Sub: Diversion of 21.00 ha Protected Forest land for laying of 33 KV line Saleha to Kalda in favour of Executive Engineer, Madhya Pradesh, Pourve Kshetra Viduyat Vitaran co. Ltd (M.P.P.K.V.V.Co. Ltd) in Panna District of M.P.

49th Meeting of Regional Empowered Committee, Bhopal
Dt. 25/02/2020

Agenda No 7

✓ **✓** **Diversion of 21.00 ha Protected Forest land for laying of 33 KV line Saleha to Kalda in favour of Executive Engineer, Madhya Pradesh, Purva Kshetriya Vidhuyat Vitaran Co. Ltd (M.P.P.K.V.V.Co. Ltd) in Panna District of M.P (6-MPC007/2020-BHO).**

DSS Analysis:

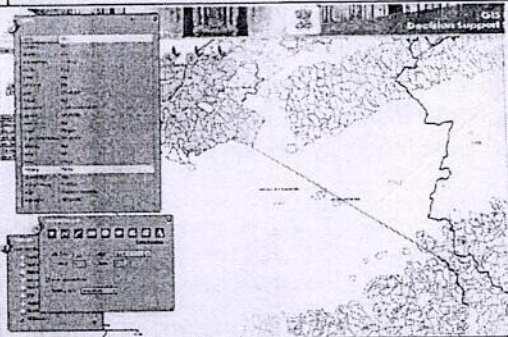
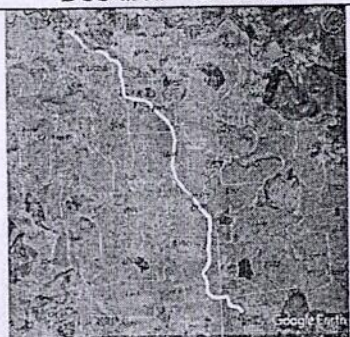
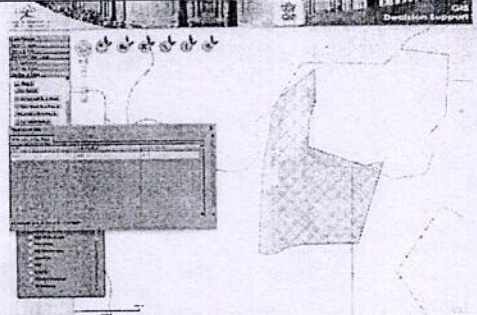
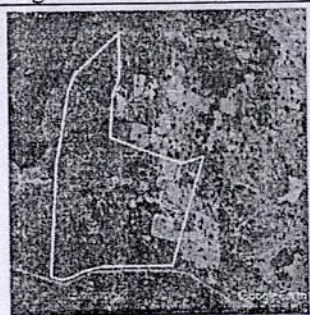
- 2) Cost Benefit analysis not submitted.
- 3) Complete CA scheme not uploaded on webportal.
- 4) Part-II & III wrongly uploaded on webportal.
- 5) DSS analysis shows, 38 ha MDF and 5.61 ha Agril. Encroachment out of 42 ha CA land

Proposed land = 21 ha		DSS area= 20.89 ha

DSS Image		Google earth Image	
Proposed CA land = 42 ha		DSS area= 49.27 ha	
		38 ha MDF and 5.61 ha Agril. Encroachment

1. The order of Hon'ble NGT dt. 07/03/2012 which is give at Para 18 of APCCF (LM) proposal forwarding letter dt. 07/02/2020 shall be made available to this office.
2. The C:B analysis shall be uploaded and submitted.
3. Correct copy of Part-II (recommendation of DFO) and Part-III shall be uploaded.
4. DSS analysis shows, 38 ha MDF and 5.61 ha Agriculture encroachment out of 42 ha CA land, the revised CA area in open forest shall be submitted.
5. The revised site specific CA scheme shall be submitted as per the Para 2.8 (iii) of FCA Handbook 2019 and shall include the following points also:
 - a) Standard size Saplings to be planted (Minimum standard height and minimum collar girth species wise) as approved by the State Govt.
 - b) Soil & moisture conservation works.
 - c) Regeneration cleaning.
